OXFORDSHIRE
STRATEGIC RAIL FREIGHT INTERCHANGE

Chapter 3: Transport
Appendix 3.1: Transport Assessment Part 10 of 11 – Appendices 35 to 43

M40 J9 HIGHWAY DESIGN REVIEW

Project	**Oxfordshire Strategic Rail Freight Interchange (OxSRFI)**		
Document Number	OxSRFI-BWB-GEN-XX-RP-CH-0015	**BWB Ref**	NTH2479
Author	Simon Hilditch	**Status**	S3
Checked	Ryan Picknell	**Revision**	P01
Approved	Simon Hilditch	**Date**	24.03.2026

FIGURE 1 – Location of problems identified in this audit

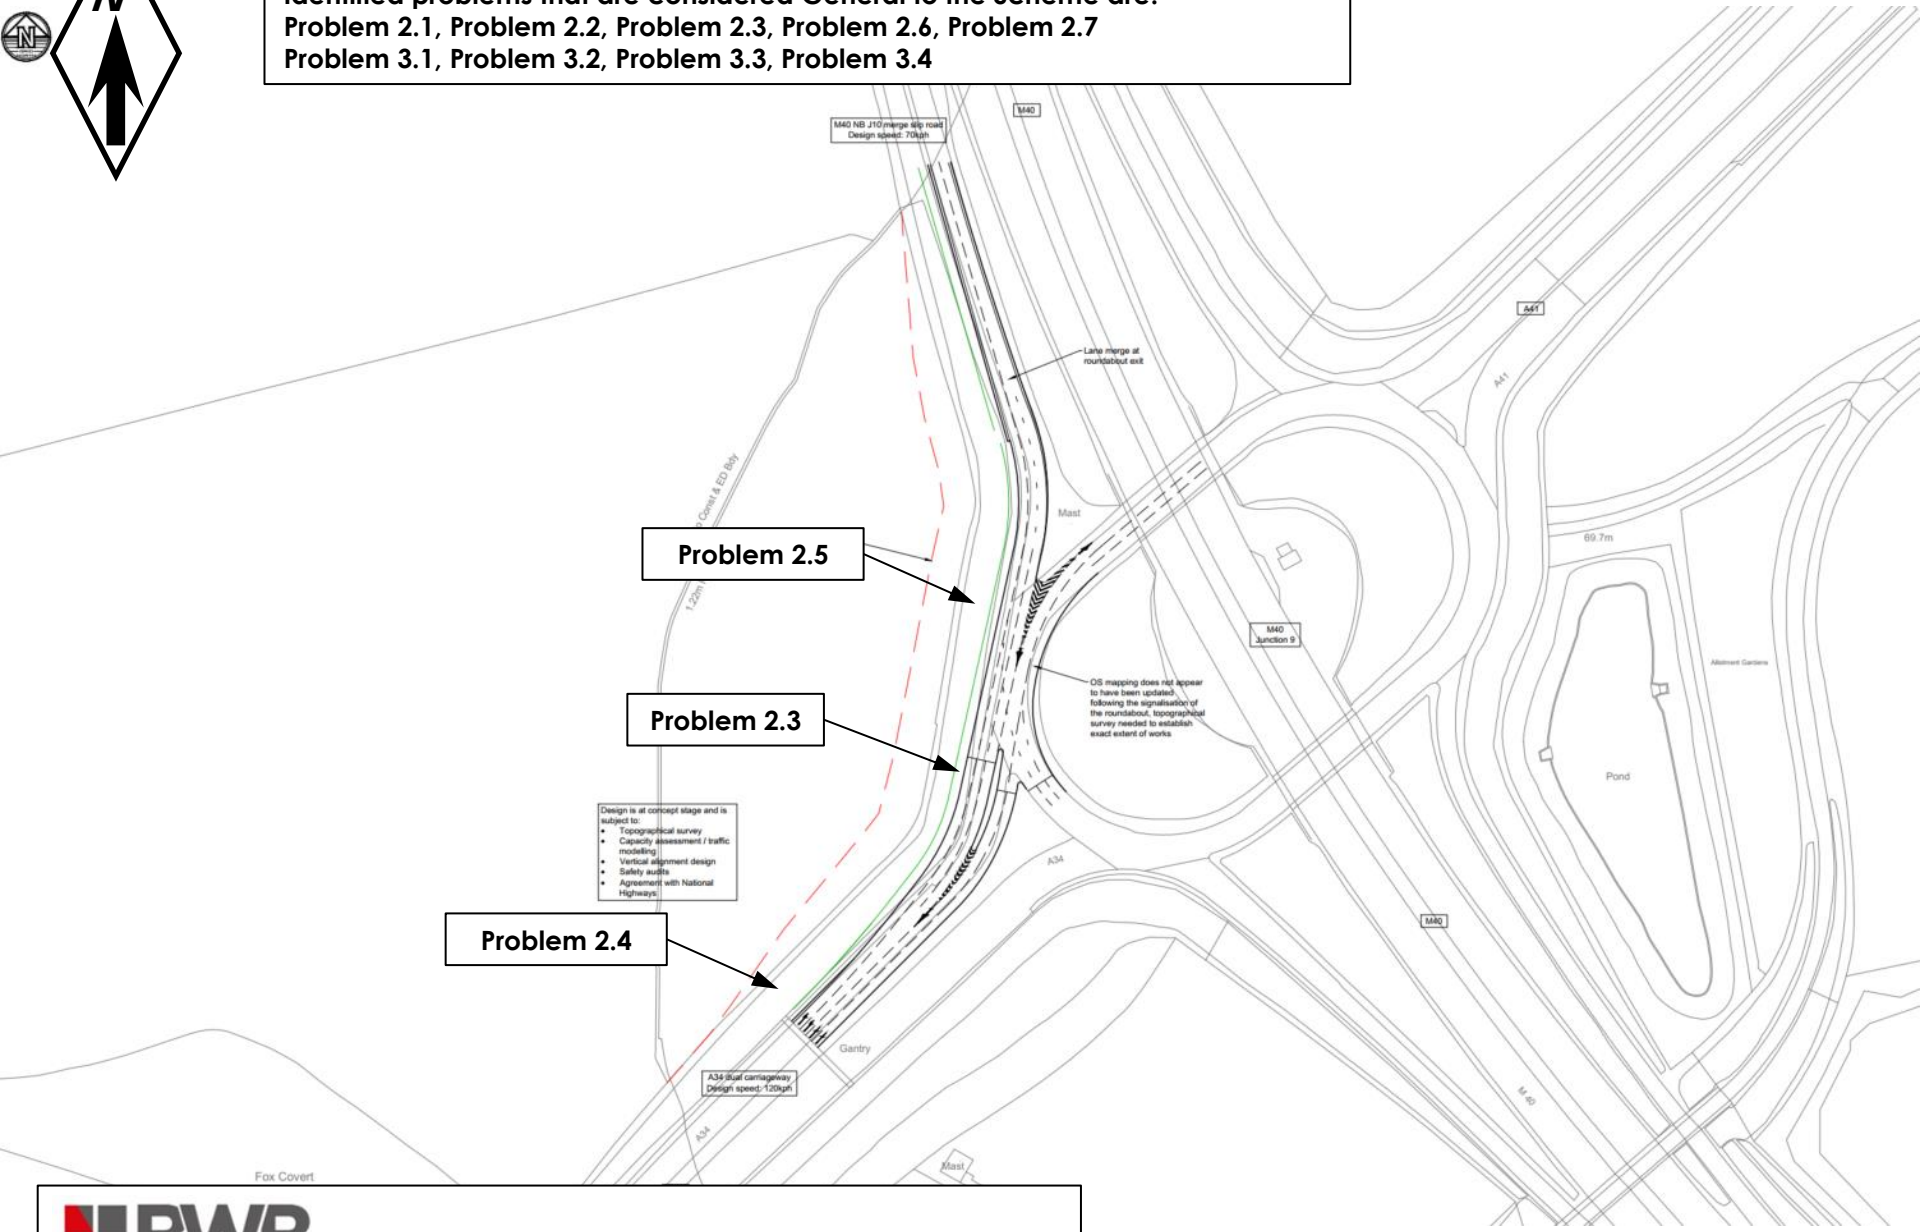
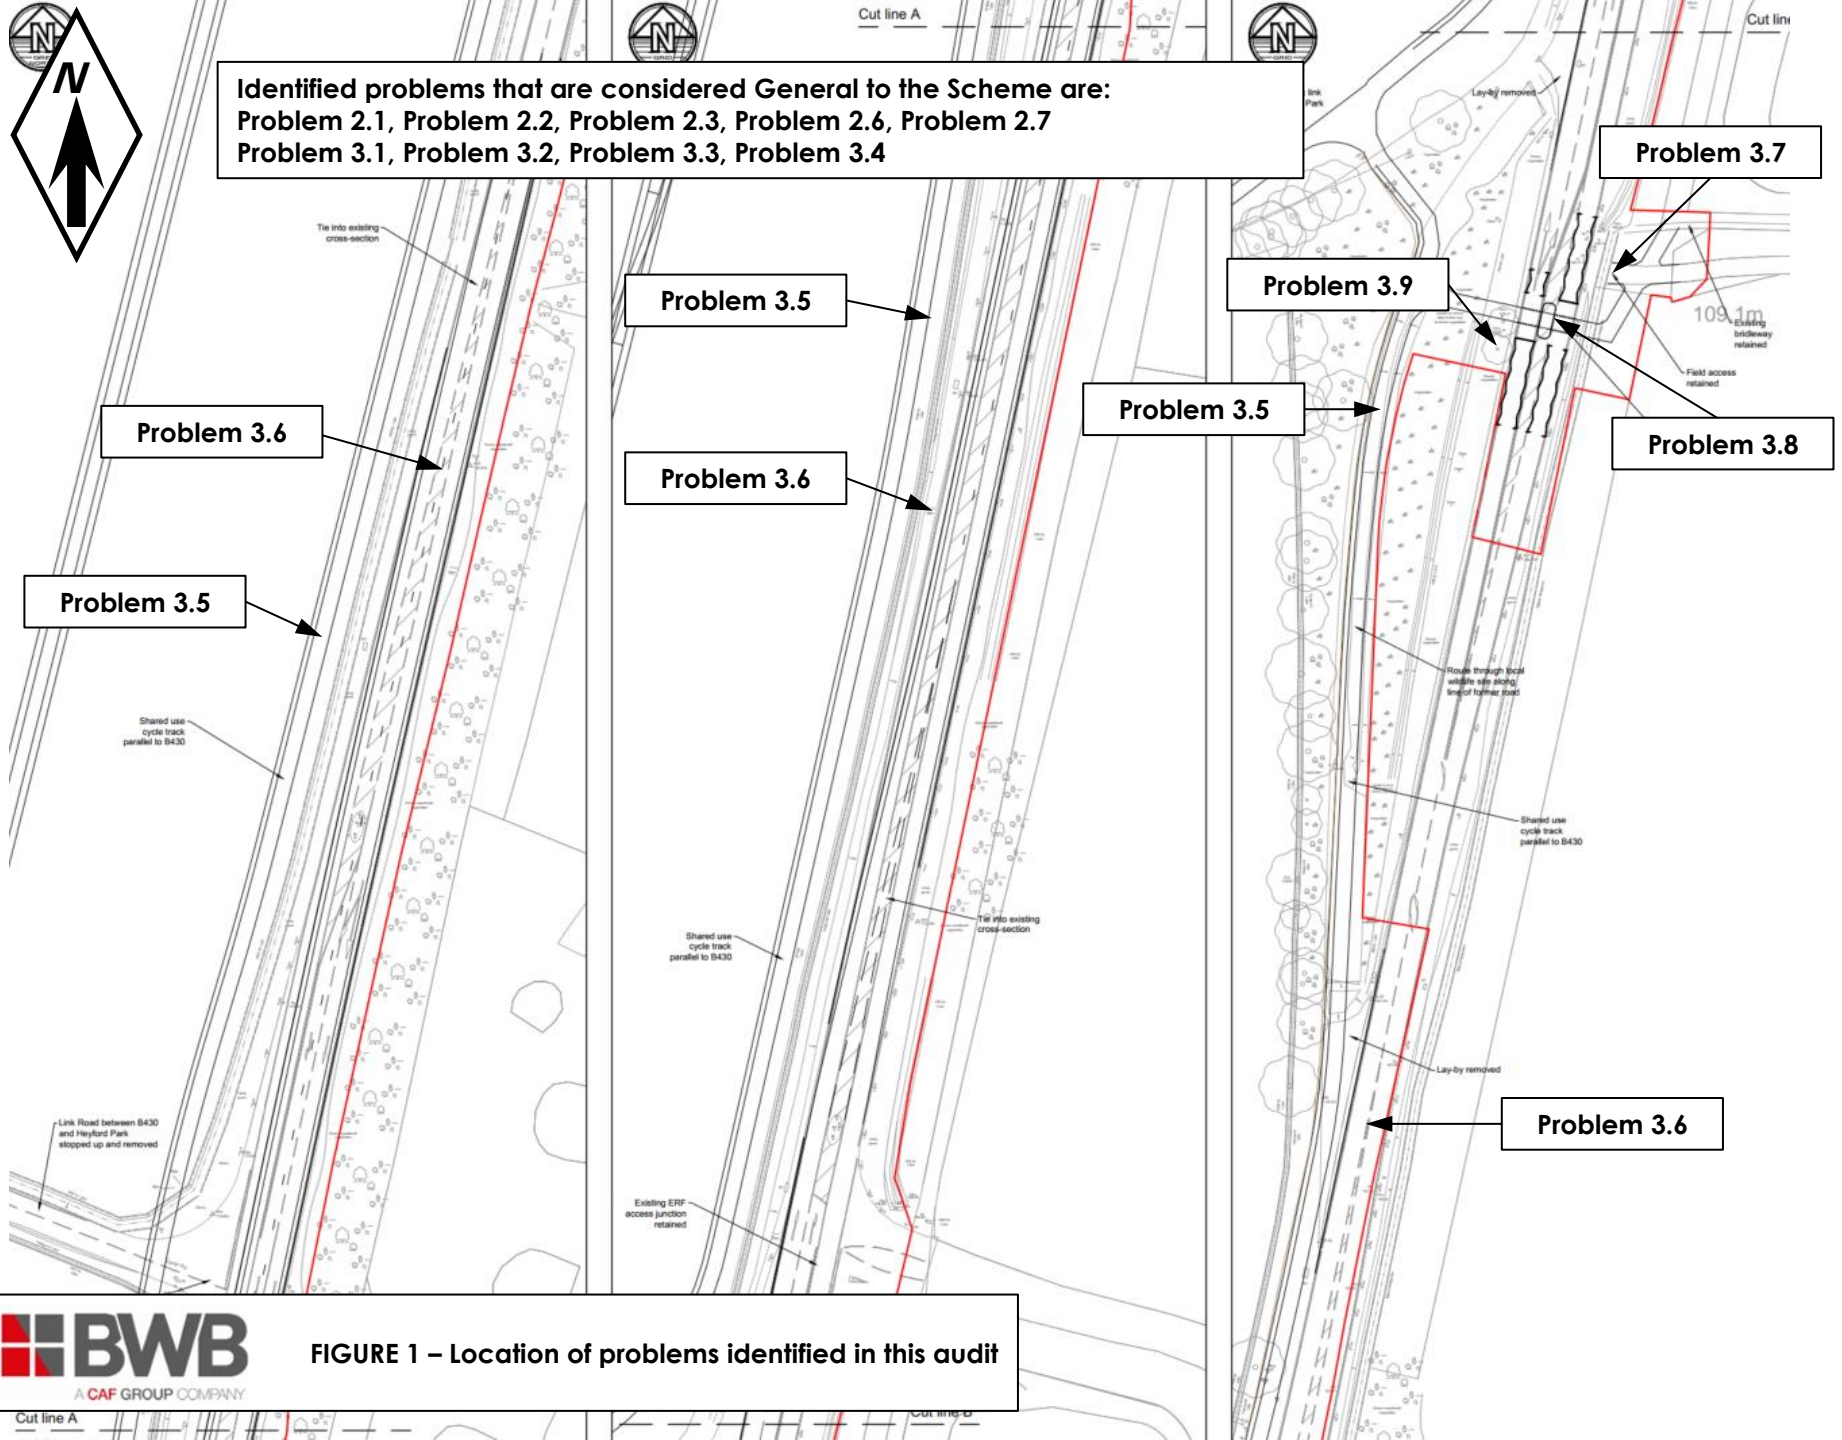
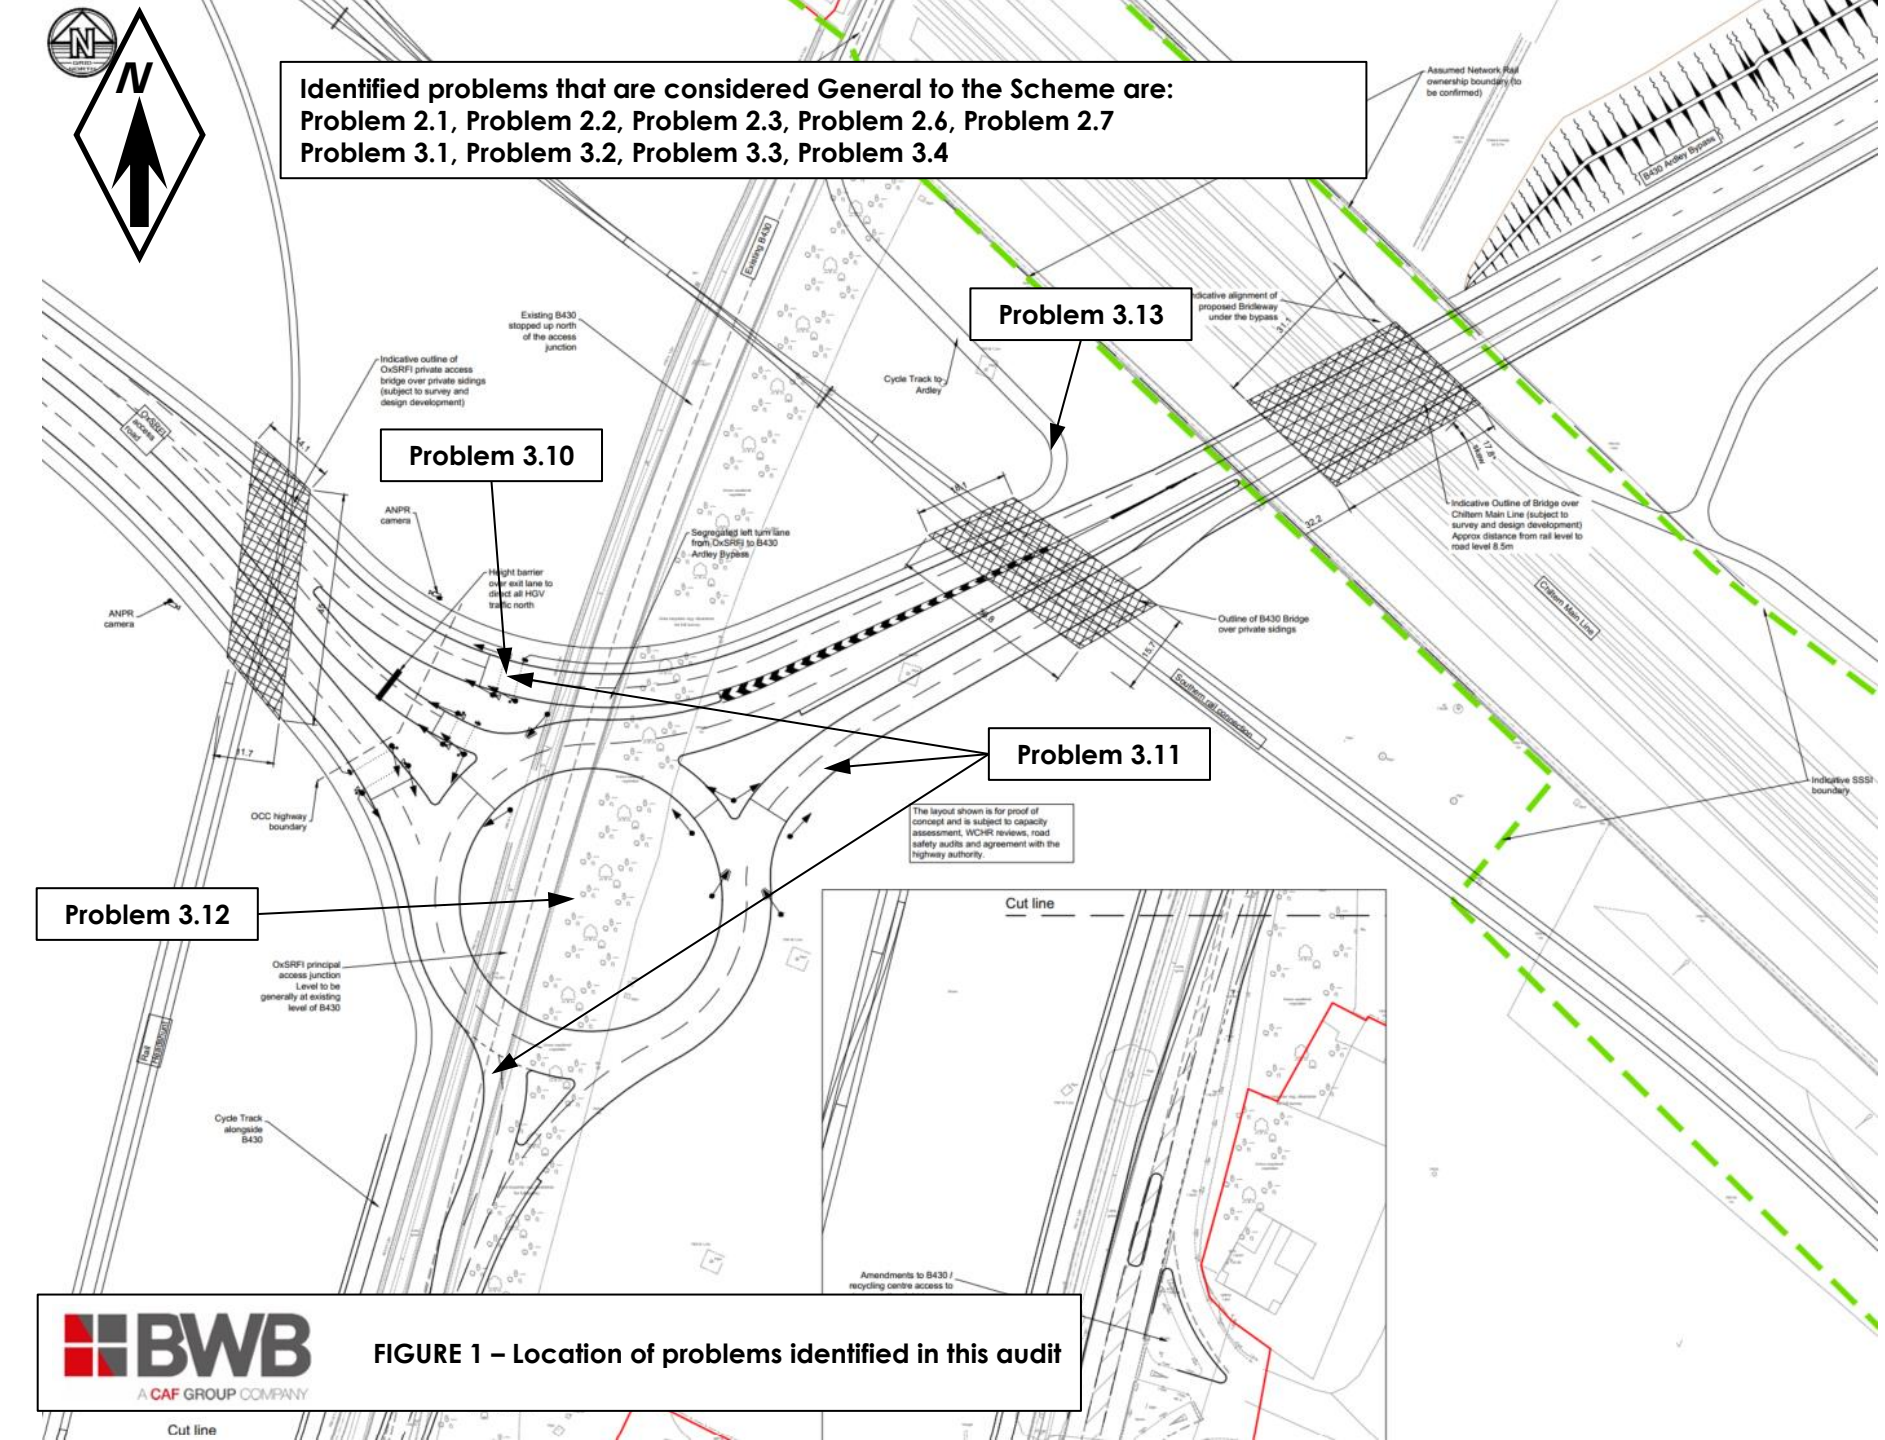
1.5 The terms of reference of the audit are as described in GG 119. The Audit Team has examined and reported only on the road safety implications of the scheme as presented and has not examined or verified the compliance of the designs to any other criteria. All comments and recommendations refer to the highway proposal drawings and the locations have been indicated on **Figure 1**.

Identified problems that are considered General to the Scheme are:
Problem 2.1, Problem 2.2, Problem 2.3, Problem 2.6, Problem 2.7
Problem 3.1, Problem 3.2, Problem 3.3, Problem 3.4
